NRL/MR/7441--94-7516

Digital Mapping, Charting, and Geodesy Analysis Program Technical Review of Vector Smart Map Prototypes 1 and 2

January 19, 1995

Figure 17. Ford differences between V_{Map} and ITD

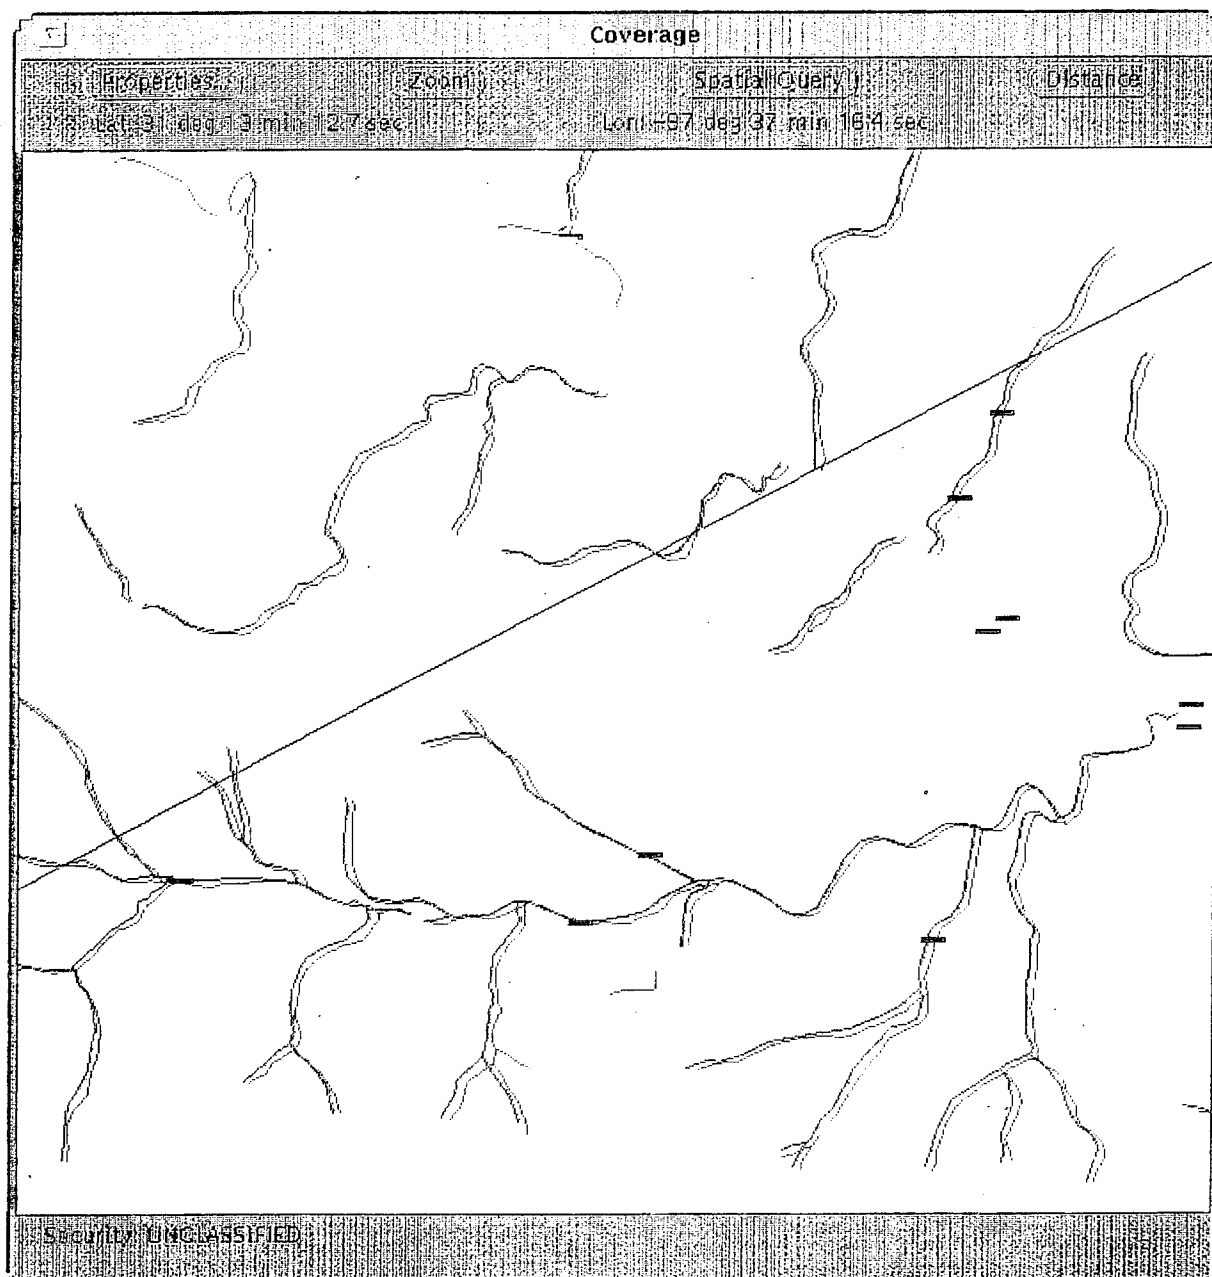
Figure 17 shows ITD Rivers/Streams (BH140) in blue, V_{Map} Rivers/Streams in red, ITD Fords (BH070) in gold, and V_{Map} Fords in black. In this figure, there is disagreement between the number and location of fords in the figure. In addition, the ITD fords are not on the ITD river.

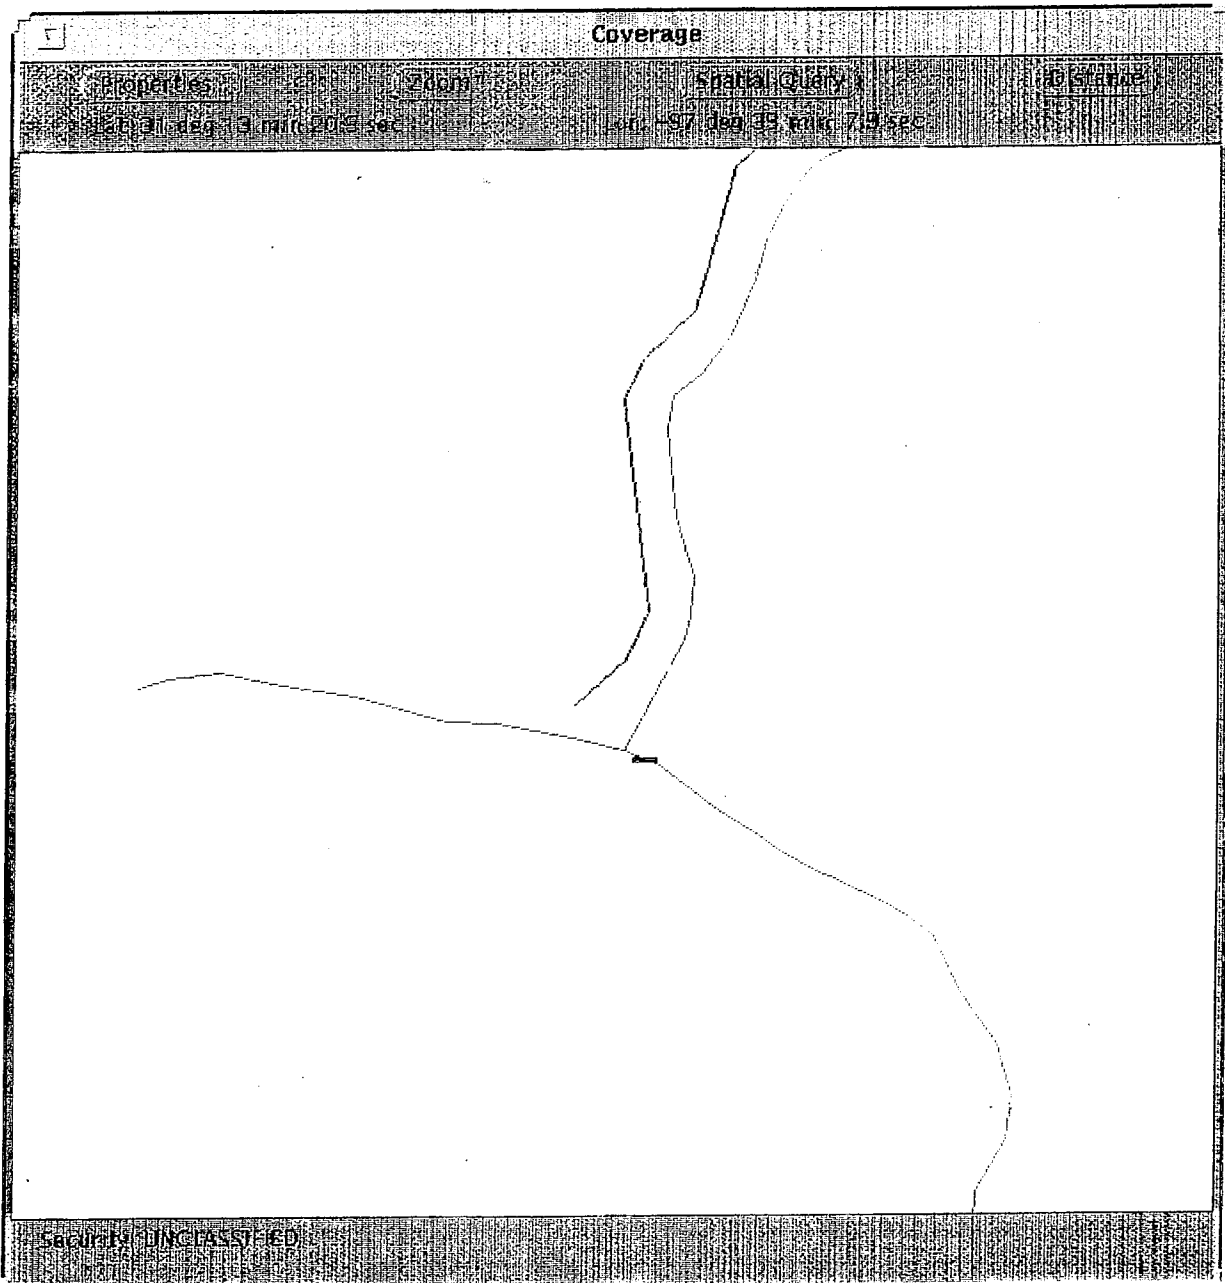
Figure 18 further shows the disagreement between the placement and number of fords.
